Recall Information Bulletin

No: C1000010 **Issued:** 9/20/2005

Re: AISIN A/T Shift Linkage

Safety Recall C1000010 - AISIN Automatic Transmission Shift Linkage

DIAGRAM 1

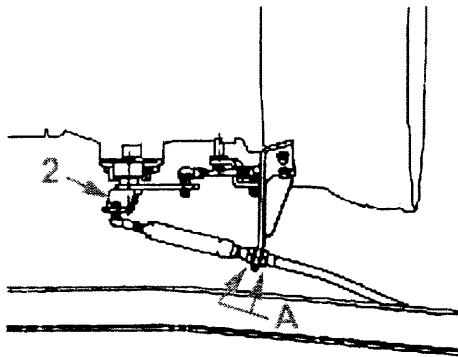
2. Lubricate the two shift lever nuts (at 3, DIAGRAM 2) with penetrating oil.
3. Remove and discard the shift cable ball joint nut (at 2, DIAGRAM 1) and disconnect the A/T control cable from the A/T control lever assembly (1).

10. If the ball joint and control lever are misaligned, loosen the two shift cable nuts (at A, DIAGRAM 1), and slide the shift cable forward or rearward to align the ball joint and lever hole.

13. Install a new adhesive-coated flange nut on the A/T control cable (at 2, DIAGRAM 1) and torque to 3-4.4 ft. lbs. (4-6 Nm).
14. Place the A/T shifter in the cab into each gear selection, confirming that the lever moves smoothly from Park "P" through Low "L" with no discrepancy between the gear shift indicator on the floor of the cab, the electronic gear indicator on the instrument panel and the actual gear selected at the transmission. Note: While moving through the gear selection, ensure that there are no abnormalities, such as binding while moving the shifter.

DIAGRAM 2

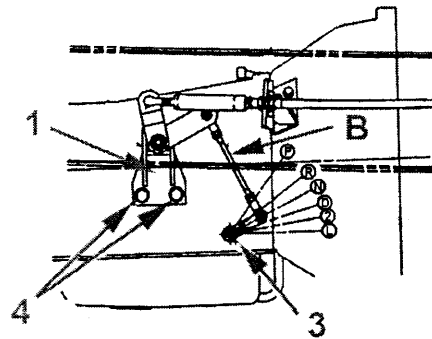
4. Remove and discard the inner and outer shift lever nuts (at 3, DIAGRAM 2) and the A/T control lever assembly flange bolts (at 4, DIAGRAM 2). Then, remove the shift lever assembly (at 1, DIAGRAM 2). **NOTE: Use extreme caution when removing the shift lever nuts if heavy corrosion is present, as damage to the A/T shift lever shaft could occur.**
5. Affix the new A/T control lever assembly (1) to the side of the transmission using two new flange bolts (4). Torque the flange bolts to 28-39.8 ft.lbs. (38-54 N m).

6. Install a new inner shift lever nut (3) and torque to 9.6 ft.lbs (13 Nm).
7. While holding the inner nut in place, install a new outer shift lever nut (3) and torque to 11.1 ft.lbs. (15 Nm).

15. Confirm that the shift lever remains securely in Park "P" position and that the ignition key can be easily removed from its switch.
16. If any problems during steps 14 or 15 are encountered, the A/T control rod (at B, DIAGRAM 2) must be adjusted.
